PUBLIC MEETING ENVIRONMENTAL ADVISORY COUNCIL RADNOR TOWNSHIP

May 26, 2016 THURSDAY 6:00 P.M.

Stormwater Ordinance Revision Radnor Township

Presentation May 26, 2016

STANDARD INFILTRATION BMP SPACING

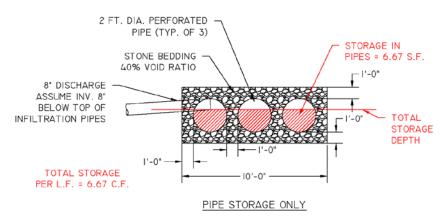
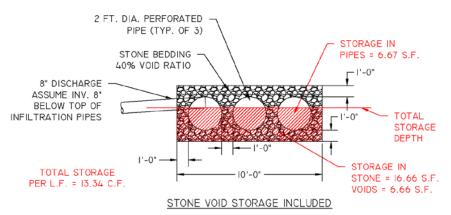
245-27-J – Underground stormwater management systems must be designed to store the two- through one-hundred-year storms within a pipe or other open system that will permit the inspection and maintenance of the system. The entire storm must be placed in the pipe (i.e., the stone bedding around the pipe is not to be included in the volume calculations).

Voids in Stone Bedding of Infiltration BMP Installations

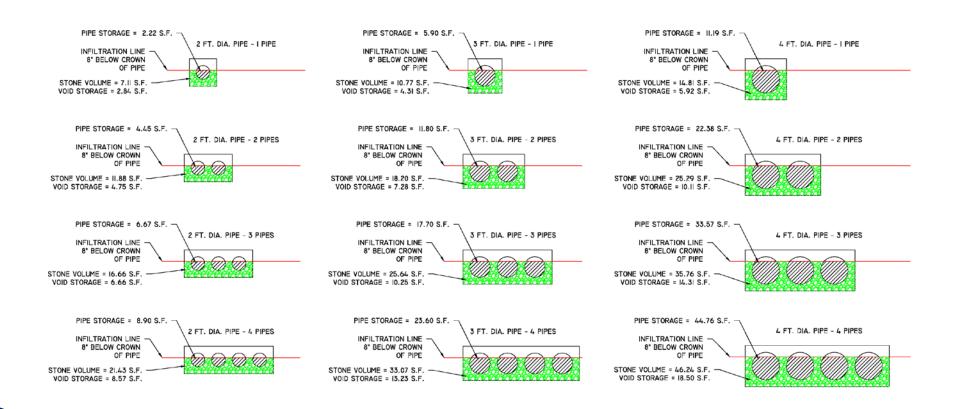
Typical Infiltration BMP Design ASSUMED VOLUME INFILTRATION

(123 STORMWATER AVENUE EXAMPLE = 375-778.5 C.F. REQUIRED)
